Planning Entitlement Application P26-0014

Oak Tree Removal Application – OTR26-01

Address: 721 28th Street B, Paso Robles, California

Purpose- Notice of Incomplete Entitlement Application-P26-0014

Exhibit A Continued

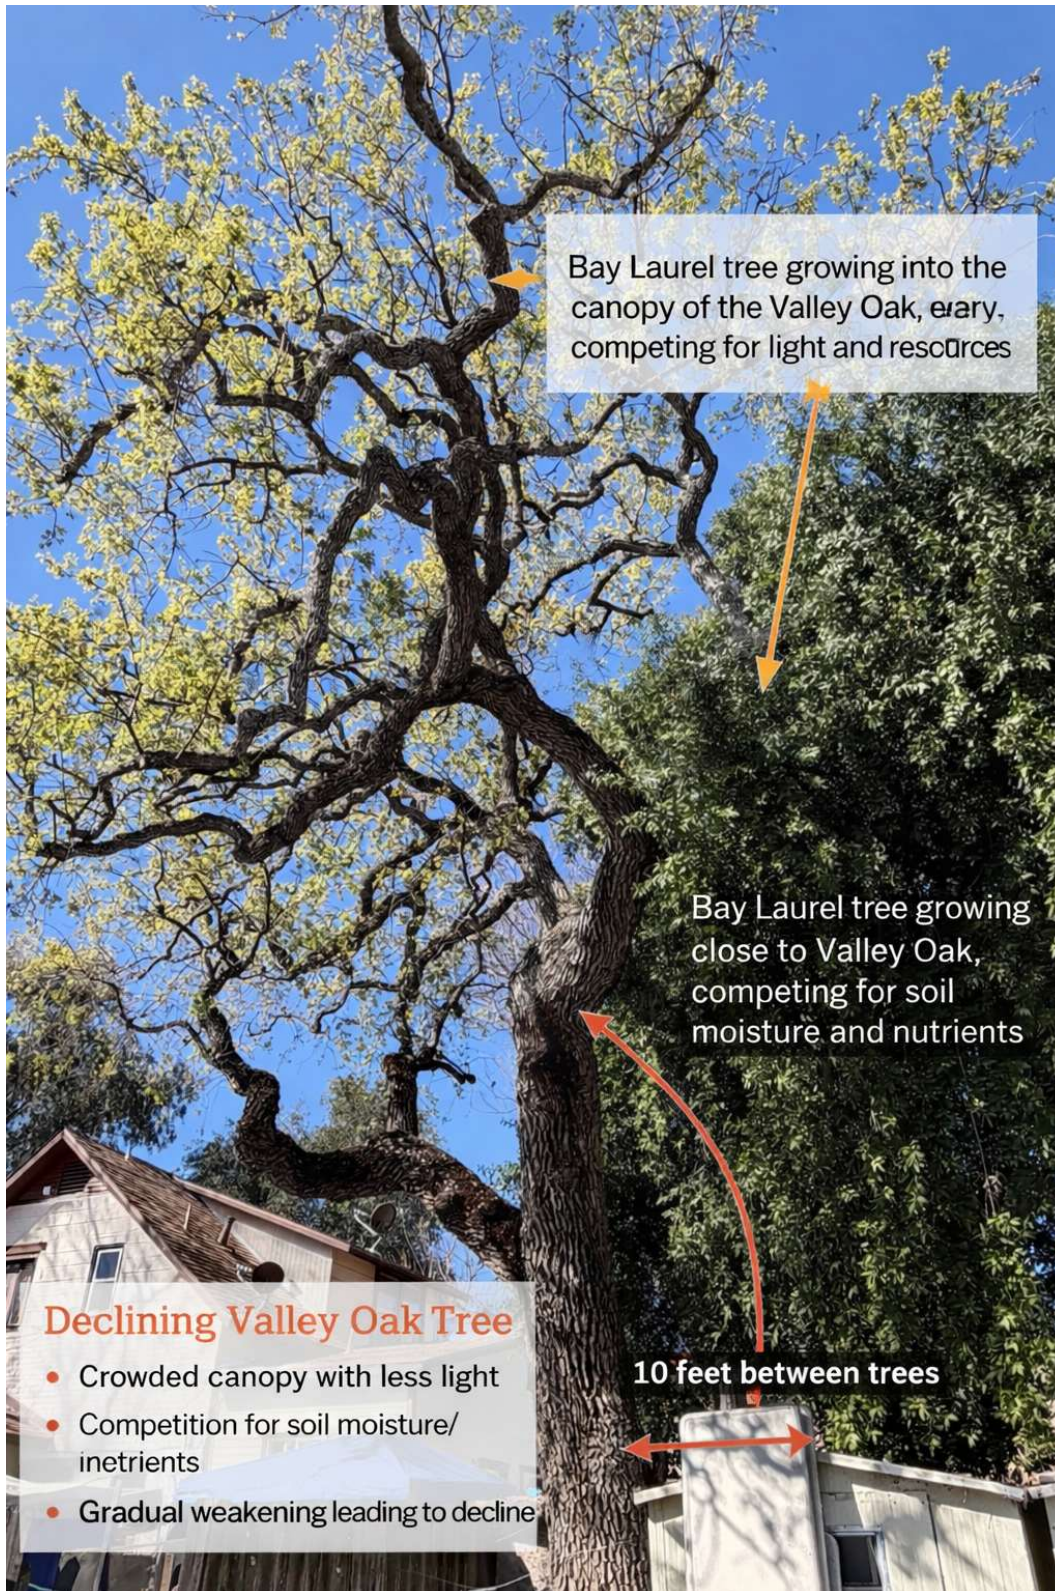
A site plan should identify the trunk location and canopy spread of both the Valley Oak and the adjacent Bay Laurel tree. The plan demonstrates canopy encroachment and root zone competition between the two trees. See attachment “A”
